APPEAL SUMMARY

Appeal ID: 20246	Project Address: 2510 SE 21st Ave
Hearing Date: 4/17/19	Appellant Name: Bob Schatz
Case No.: B-004	Appellant Phone: 5032358585
Appeal Type: Building	Plans Examiner/Inspector: Gail Knoll
Project Type: commercial	Stories: 3 Occupancy: R2, A-2 Construction Type: V-A
Building/Business Name:	Fire Sprinklers: Yes - NFPA 13
Appeal Involves: Reconsideration of appeal	LUR or Permit Application No.: 18-173879-CO
Plan Submitted Option: pdf [File 1]	Proposed use: APARTMENTS

DIVISION STREET MULTI-USE STRUCTURE
2106 SE DIVISION STREET PORTLAND, OR

TYPICAL ROOF ASSEMBLY

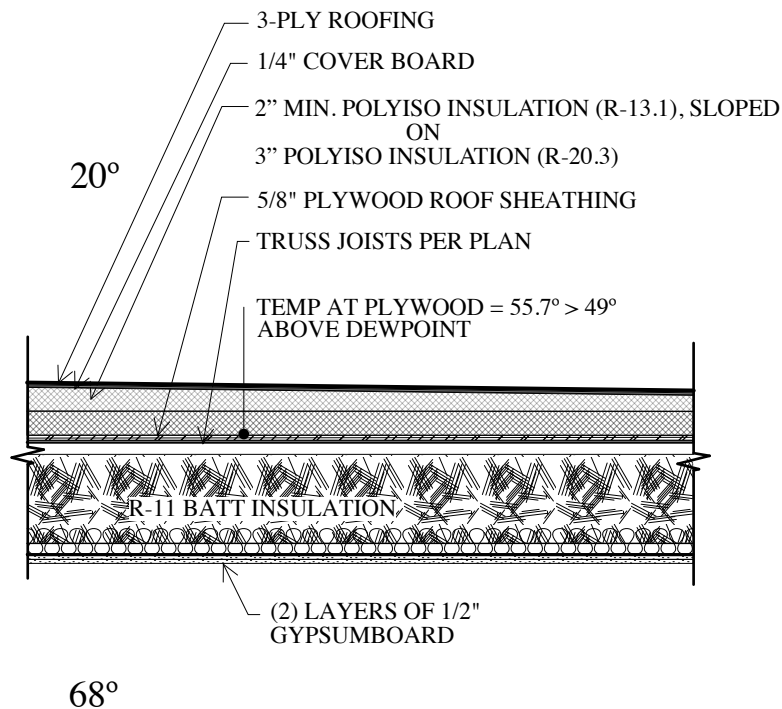
members. R-33.4 continuous rigid insulation is installed directly above the roof sheathing to maintain the roof sheathing at a temperature adequate to keep the dew point within the rigid insulation and prevent mold growth. Inside the roof cavity an additional Batt insulation is provided to R-11. The total provided roof insulation is R-46.53. The following notes have been added to the plans: ROOF SHEATHING TO BE COMPLETELY AIR SEALED WITH ZIP SYSTEM TAPE, TYP. RIGID INSULATION TO BE INSTALLED IN MULTIPLE LAYERS TO LIMIT INSULATION BY- PASS FROM GAPPING OF INSULATION. ALL FIXTURES INSTALLED IN THE CEILING SHALL BE SEALED WITH LOW EXPANSION SPRAY FOAM SEALANT. THE MOISTURE CONTENT OF IN THE ROOF STRUCTURE MUST BE LESS THAN 18% PRIOR TO COVERING. RIGID INSULATION MUST BE KEPT DRY. PERFORM A FULL FLOOD TEST TO ENSURE LEAK FREE INSTALLATION OF ROOF MEMBRANE.

Reason for alternative 3rd Reconsideration Text: The alternate is required because continuous exterior insulation is preferable over providing ventilation openings into (and therefore all of the insulation within) the structural cavity. The slope on the roof will be obtained through tapered insulation instead of sleepers. This new roof assembly design is very close to the previously approved appeal.

$\Delta T =$ 48 DEGREES (68°-20°)

Related Formula: (Cumulative R / Total R) x ΔT

Relative Humidity at 68°	30%	40%	50%
Dew Point Temperature	36°	42.5°	49°
Worst Case Scenerio

Unvented attic space: Granted as proposed.
